ADDENDUM NO. 4

PROJECT: Washtenaw ISD – High Point School
DESCRIPTION: Architectural and MEP
BID PACKAGE RELEASE NUMBER: 003
CLARK/AXIOM PROJECT NO: 2832/1004

PROJECT: Washtenaw ISD – High Point School

1 Gymnasium Building Section
D4.1-BP1 SCALE: 1/4"=1'-0"

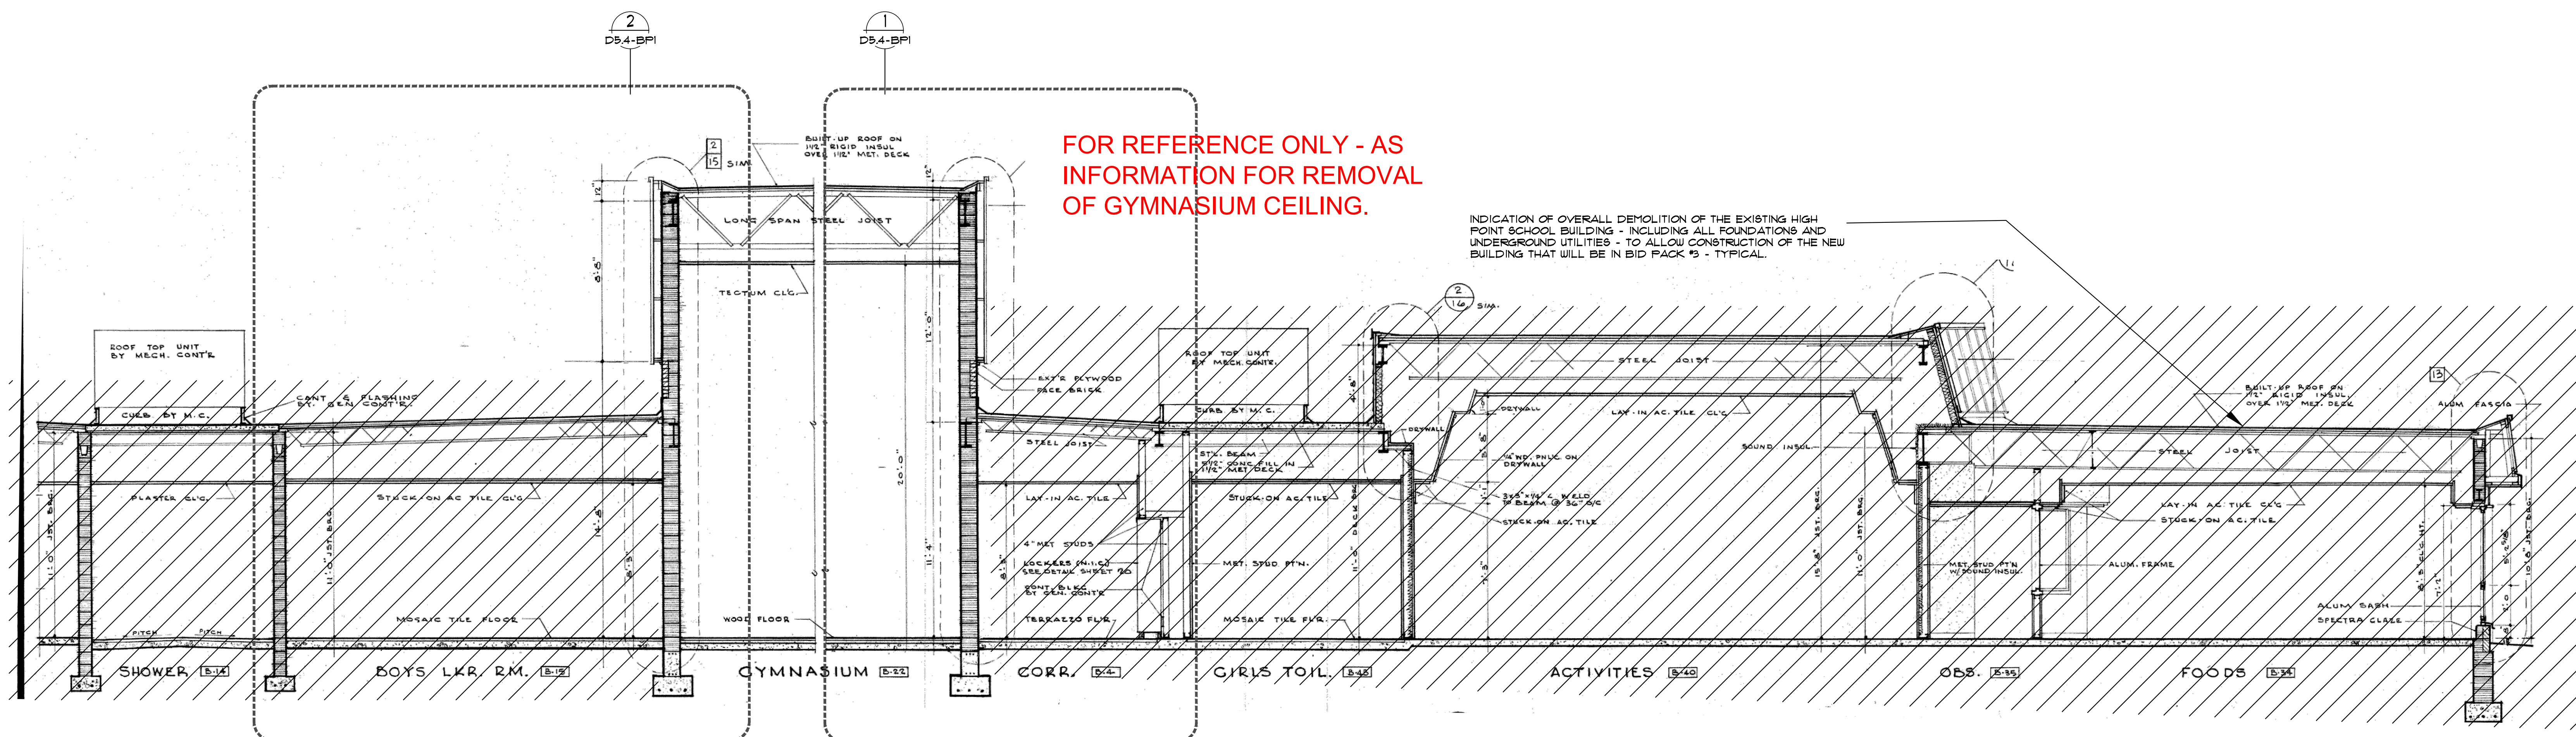
- B. Added note at EXISTING GYMNASIUM B107 for light and ceiling demolition as indicated. Reference added sheets D4.1-BP1 and D4.2-BP1.
- AD-11 Refer to Drawing No. A2.1E-BP3 (reissued):

PROJECT NO.
19040
DRAWING NO.
A2.1B-BP3

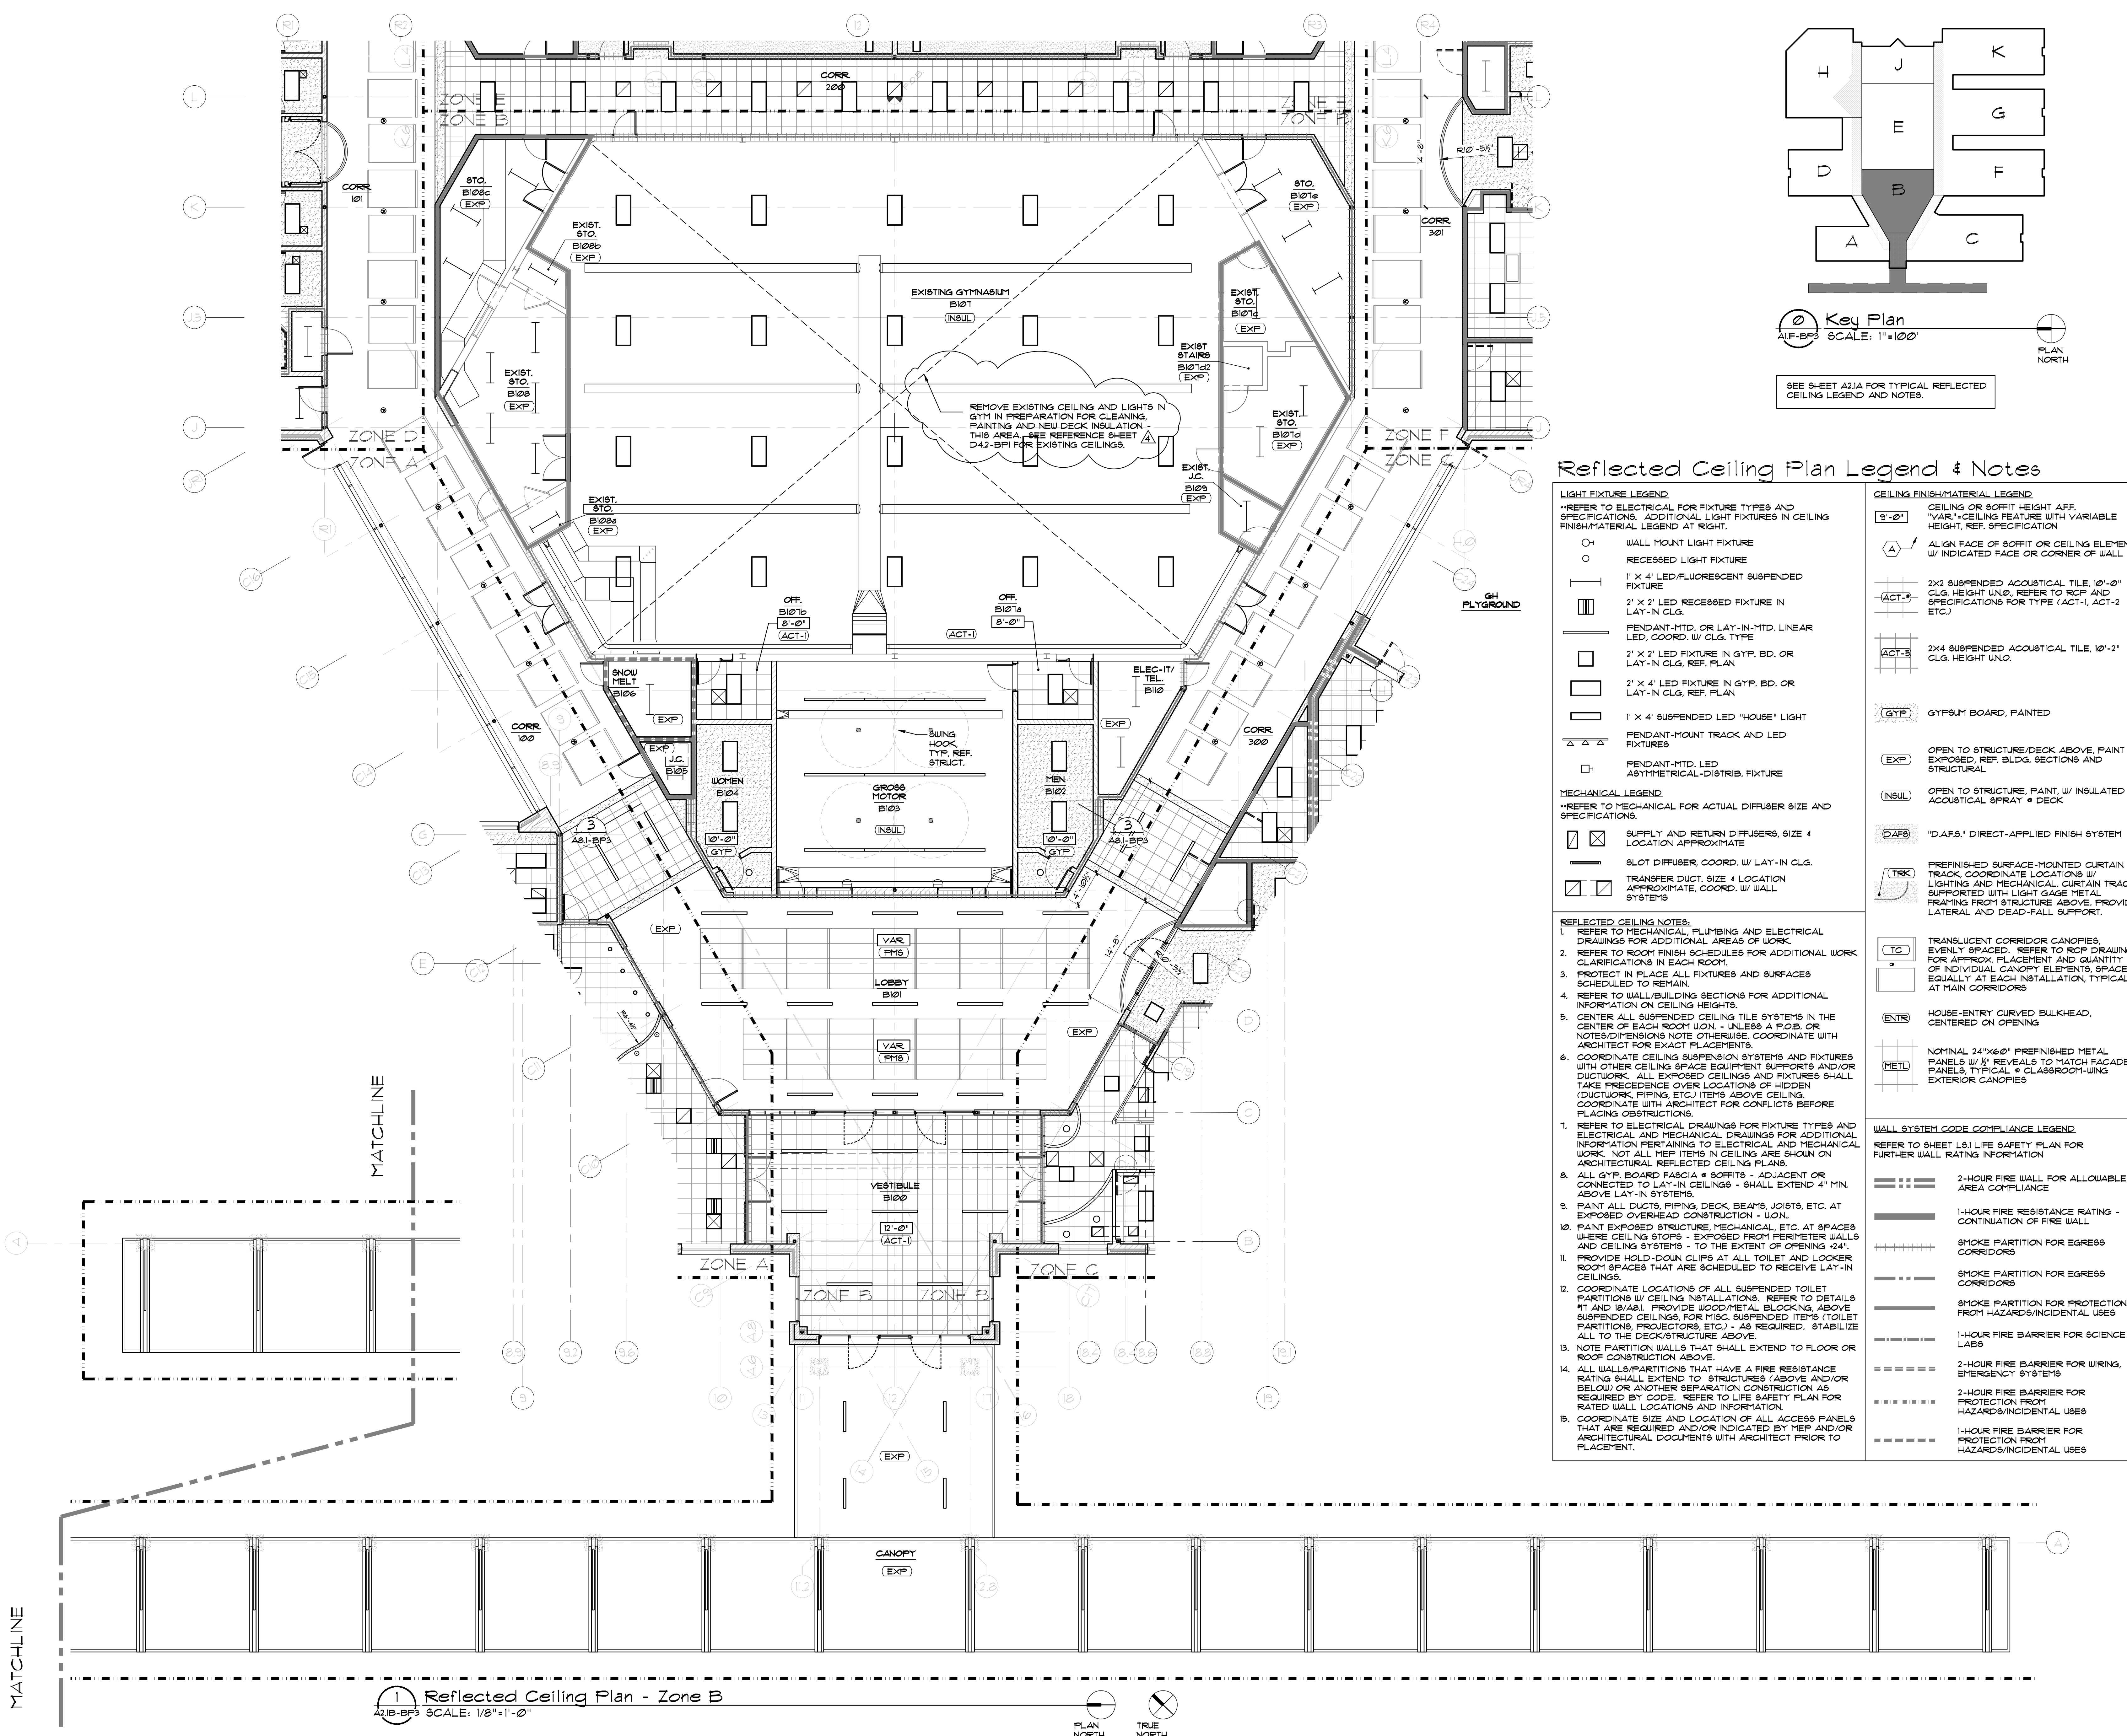
- A. Revised door number to be "K107.1" at PREP K107.
- AD-10 Refer to Drawing No. A2.1B-BP3 (reissued):
- A. Revised REFLECTED CEILING PLAN LEGEND & NOTES at note "TC" to read as follows: TRANSLUCENT CORRIDOR CANOPIES, EVENLY SPACED. REFER TO RCP DRAWING FOR APPROX. PLACEMENT AND QUANTITY OF INDIVIDUAL CANOPY ELEMENTS, SPACED EQUALLY AT EACH INSTALLATION, TYPICAL AT MAIN CORRIDORS. This revision applies to this sheet and the following not reissued sheets: A2.1A-BP3, A2.1C-BP3, A2.1D-BP3, A2.1F-BP3, A2.1G-BP3, A2.1H-BP3, A2.1J-BP3, A2.1K-BP3.

1 Reflected Ceiling Plan - Zone E
A2.1E-BP3 SCALE: 1/8"=1'-0"

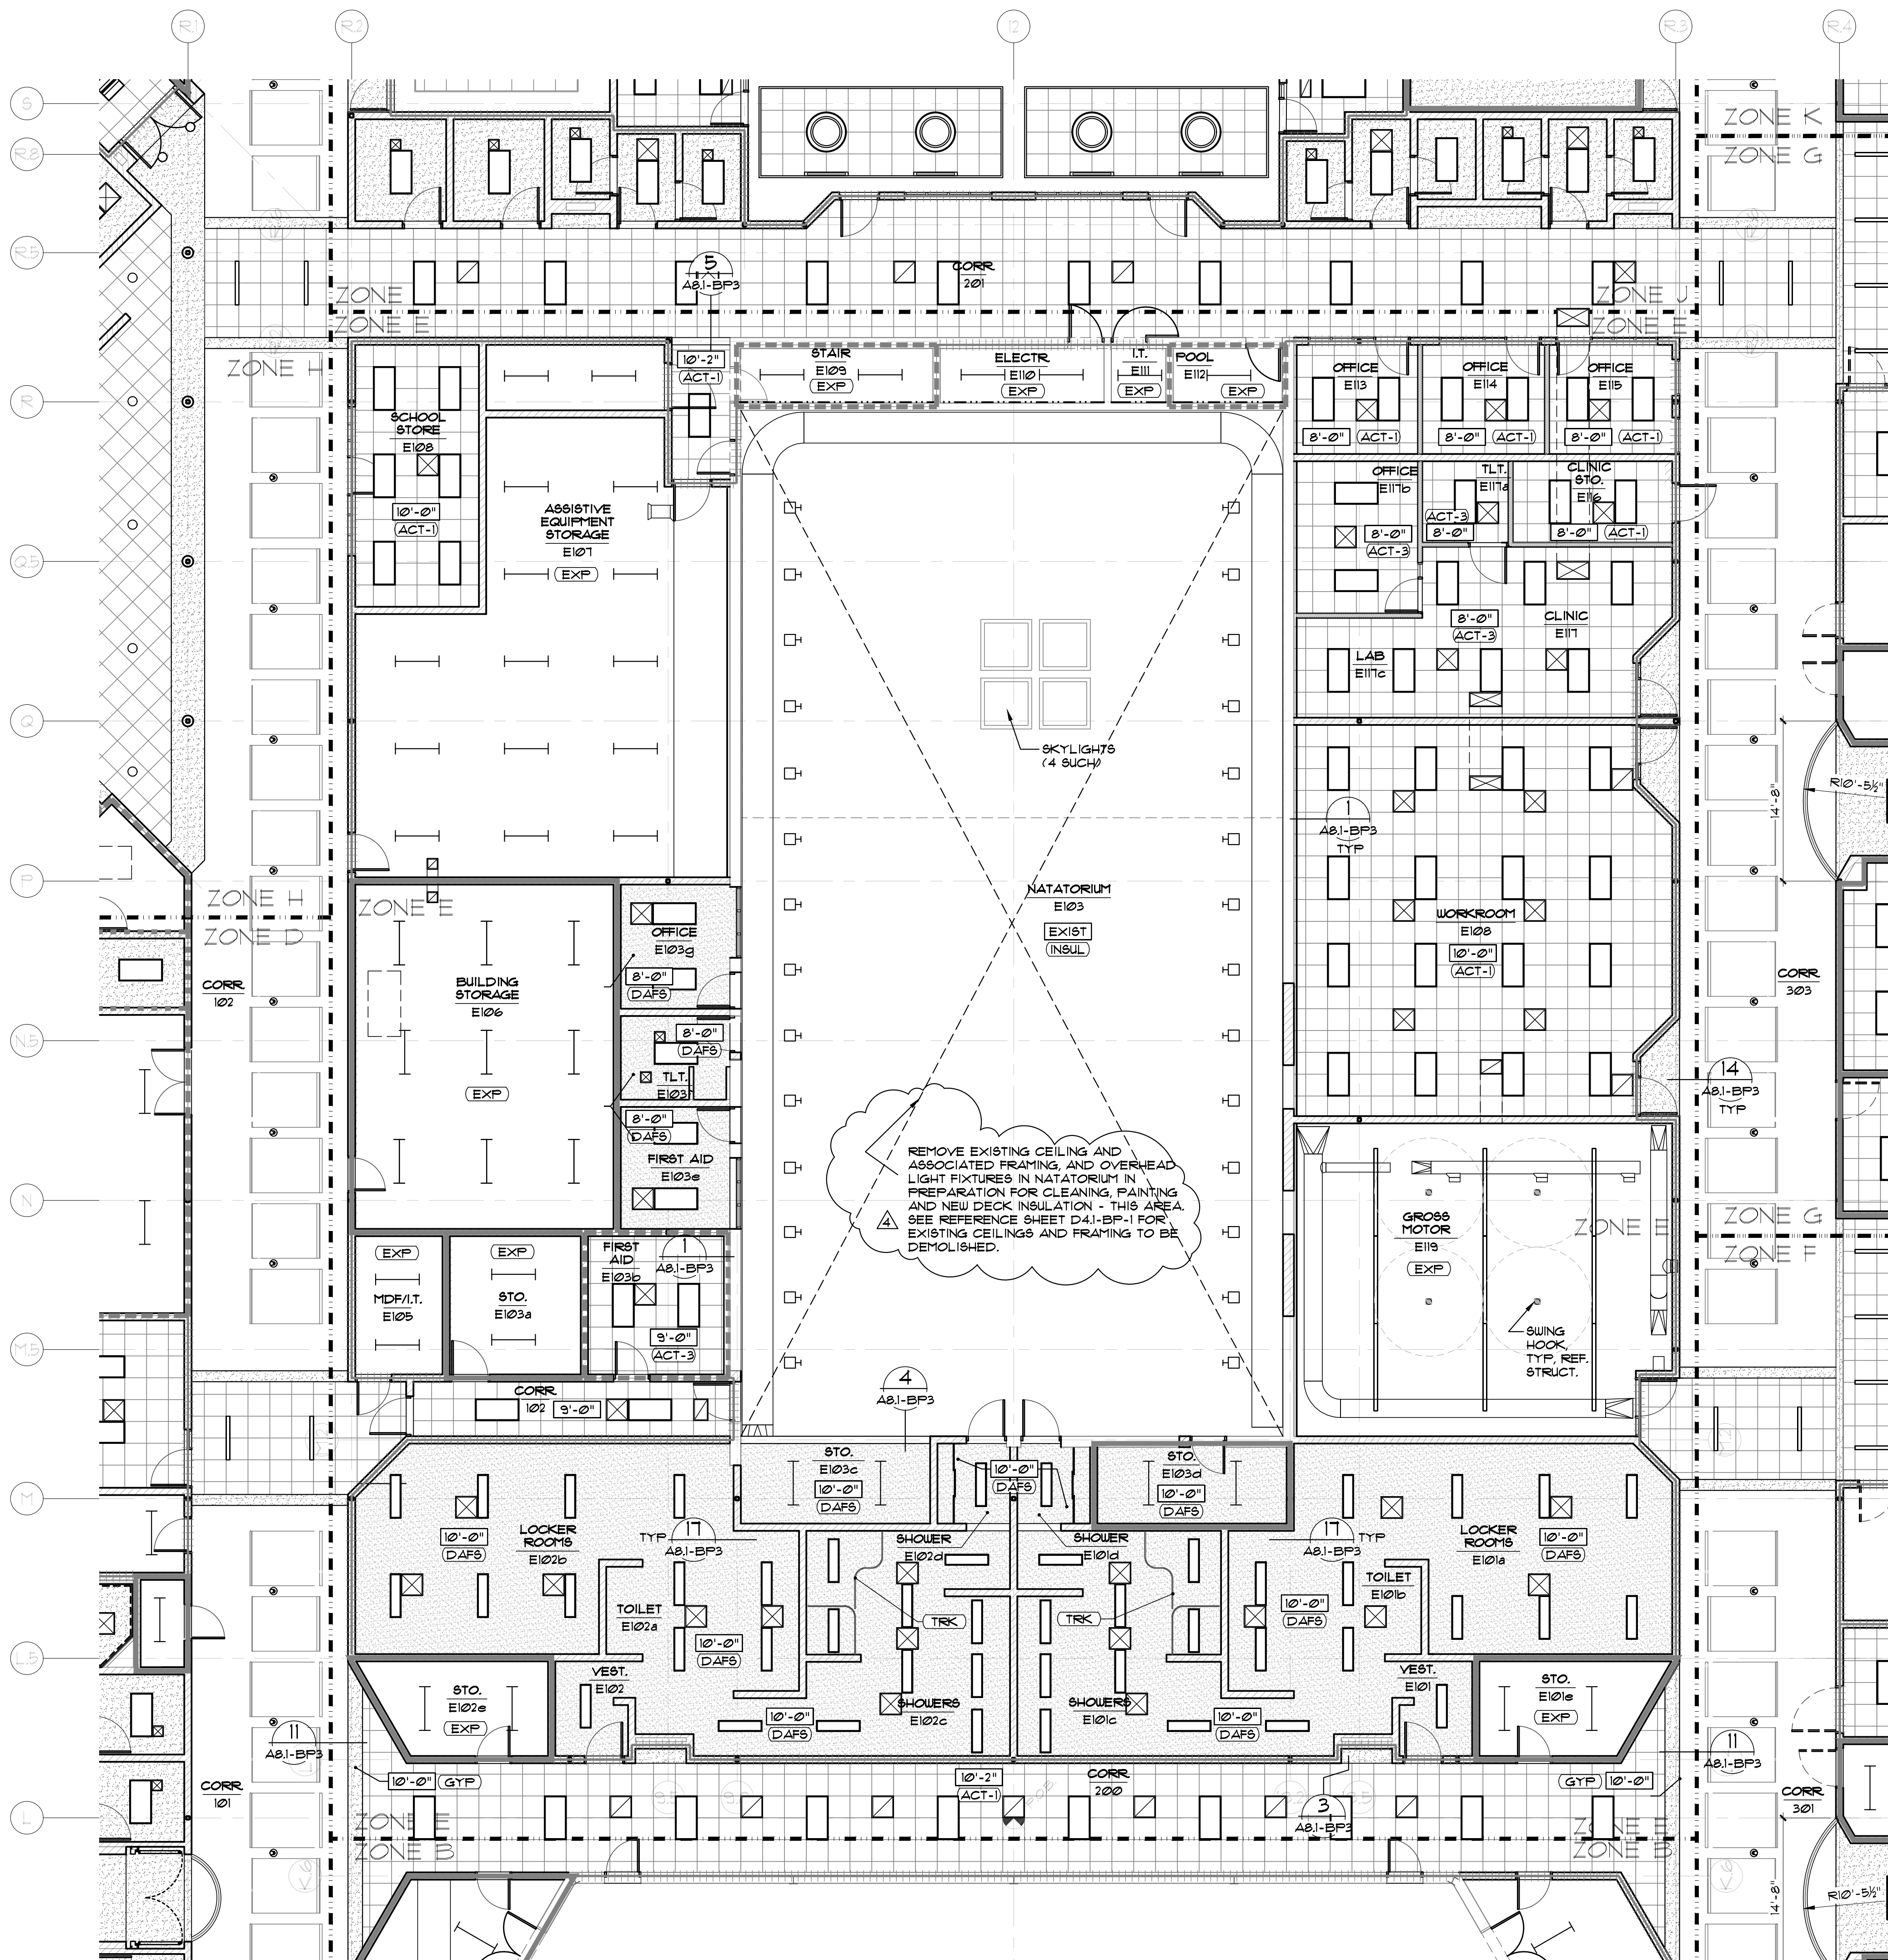
- A. Revised REFLECTED CEILING PLAN LEGEND & NOTES at note "TC" to read as follows: TRANSLUCENT CORRIDOR CANOPIES, EVENLY SPACED. REFER TO RCP DRAWING FOR APPROX. PLACEMENT AND QUANTITY OF INDIVIDUAL CANOPY ELEMENTS, SPACED EQUALLY AT EACH INSTALLATION, TYPICAL AT MAIN CORRIDORS.

- B. Added note at NATATORIUM E103 for light and ceiling demolition as indicated. Reference added sheets D4.1-BP1 and D4.2-BP1.
